SEWAGE DISPOSAL SYSTEM

DEPARTMENT OF HEALTH AND MENTAL HYGIENE

SUBDIVISION Ashleigh Knolls LOT 49 ROAD 7141 Moorland Drive

RE: Ashleigh Knolls, Lot #49
7141 Moorland Drive
Well Permit #HO-94-0583

ENLARGEMENT
OF TANK
AREA

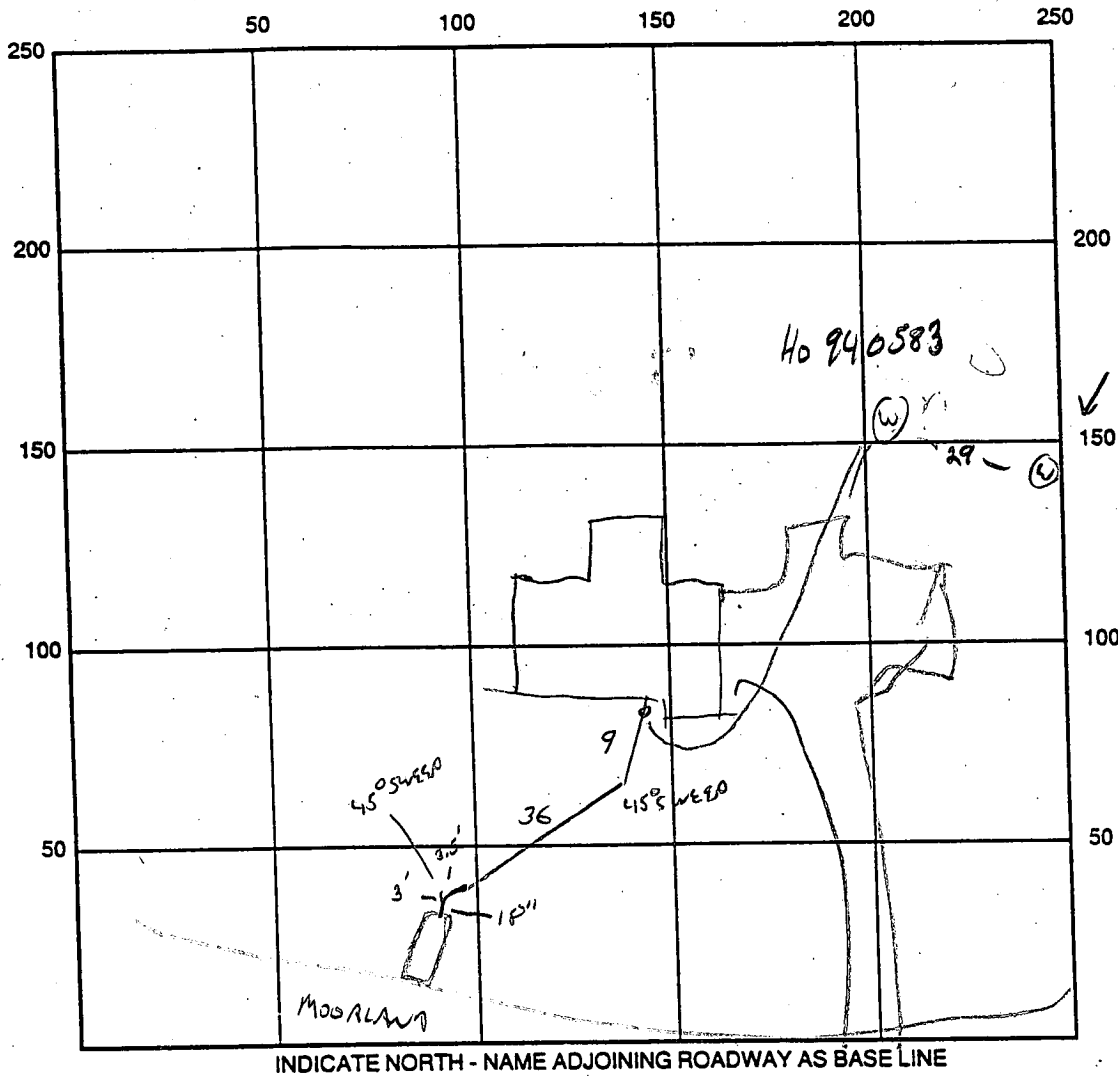
REMARKS: 9/24/98 CONTRACTOR WILL BE STOPPING AROUND SEWER AT WALL
WHERE NOT SUPPORTED BY ORIGINAL GROUND W/SL. LINES NOT
INSTALLED OK TO COVER SPOT.

9/25/98 well lining/pitless adapter connection ok,
BUT CASING PULLED AWAY FROM GROUT AT BACK OF WELL. (CW)

9/28/98 WPI - THERE IS ANNULAR SPACE ON BOTH SIDES
OF WELL CASING BELOW PITLESS ADAPTER + MOSTLY BLOCKED W LOOSE
DIRT, MINIMAL GROUT EVIDENT, I'VE BEEN NOT ABLE TO VERIFY IF CASING
IS DAMAGED, GROUT LOOKS DEFICIENT IN ANY CASE. I WOULD ESTIMATE
THAT HOLE WAS PARTIALLY BLOCKED WHEN GROUT WAS PLACED. I ADVISE
AGAINST PLACING THIS WELL IN SERVICE WITHOUT ADDITIONAL EVALUATION
BY WELL DRILLER OR MOE. ~~BT~~

DATE SYSTEM APPROVED 12-22-98 INSPECTOR [Signature]
12-17-98 PUMP TEST GOOD-OK, PAINT IN TANK WATER - TO BE PUMPED WILL BE OUT OF
WELL LINE COVERED, YARD GRADED & SEEDED. SERVICE FOR RE-INSPECTION.
12-18 APPROVED BY UTILITIES AFTER BEING REPAIRED, OK [Signature]

7141 MOORLAND

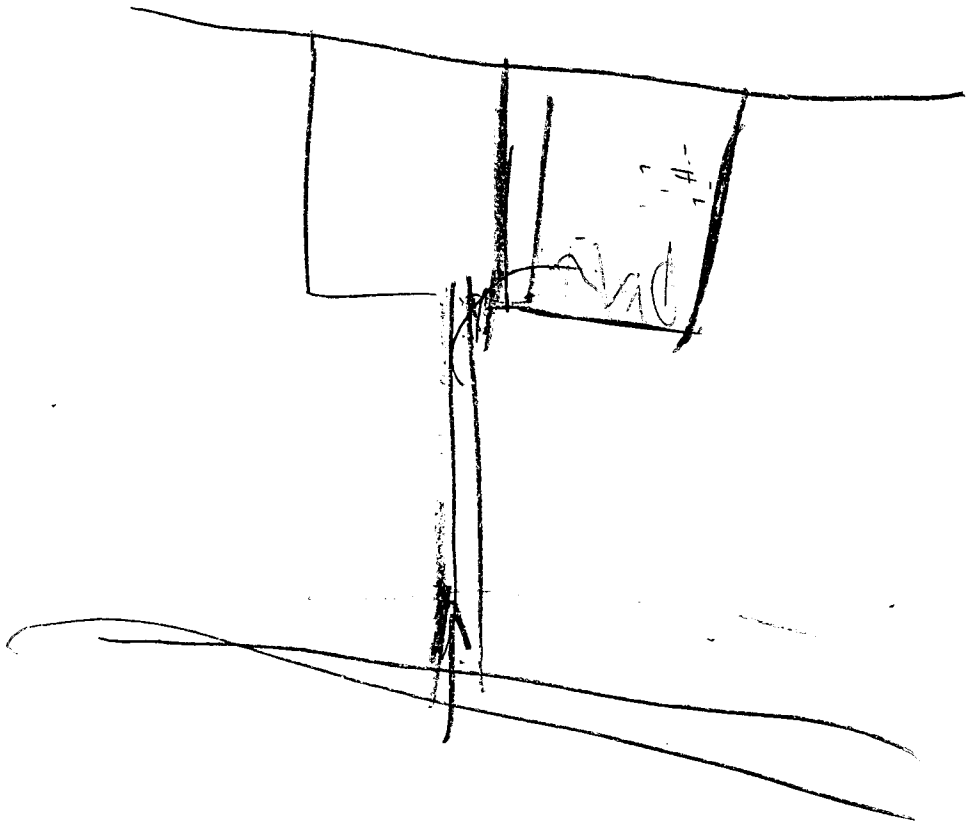
CASINL
HIT
(LAWN MOWER)

PULLED
AWAY
EVERY
GRAT
